## ALERT SERVICE BULLETIN

**UH-1H-22-22**

**SUBJECT:** MAIN ROTOR SCISSORS & SLEEVE HUB ASSEMBLY COLLECTIVE IDENTIFICATION 204-011-405-013

Figure 1 – Hub Assembly Ink-Stamped Part Number and Serial Number

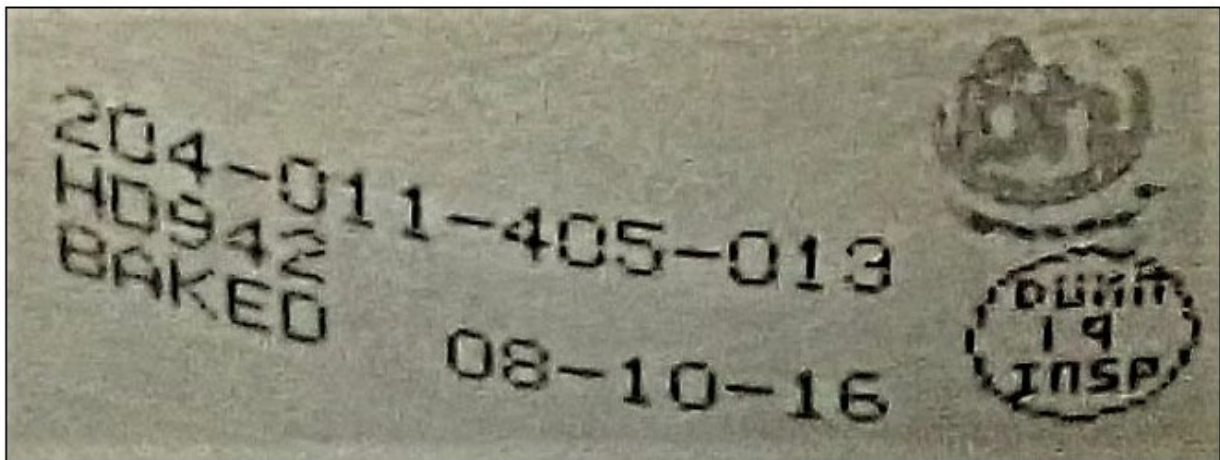
2. Confirm if there is a Historical Service Record (HSR) for the Hub Assembly (204-011-405-013) and that it contains the serial and part numbers.
3. Gain access to the Hub Assembly 204-011-405-013 and inspect for the presence of part number and serial number matching the Historical Service Record (HSR) at the location shown on Figure 1.

4. If the Hub Assembly is not correctly marked, as shown in Figure 1, proceed with **PART II**.
5. If the Hub Assembly is correctly marked, make an entry in the helicopter logbook and historical service records indicating findings and compliance with **Part I** of this Alert Service Bulletin.

2. If the Hub Assembly has an ink-stamped part and serial number matching the HSR (refer to example shown in Figure 1), permanently mark the part and serial number on the Hub Assembly by vibro-etching or dot-peening (Figure 2).
3. If the Hub Assembly does not have a part number and serial number, create a unique serial number for each Hub Assembly. Using one or two prefix letters consistent with the company name of the operator or repair facility accompanied by a dash and 4 or 5 digits is considered as an industry serial number marking standard. Vibro-etch or

Maximum depth of vibro-etching or dot-peening shall not exceed 0.005-inch. Part and serial numbers shall be marked in the scalloped area of the hub as shown in Figure 2 of this ASB; to a minimum height of 0.062-inch (1.57 mm) and no closer than 0.100-inch (2.54 mm) to any edge.

dot-peen the Hub Assy with the part number and the assigned serial number (Figure 2). For example, Papa Tango Aviation Inc. could use “204-011-405-013 / PT-01234”.
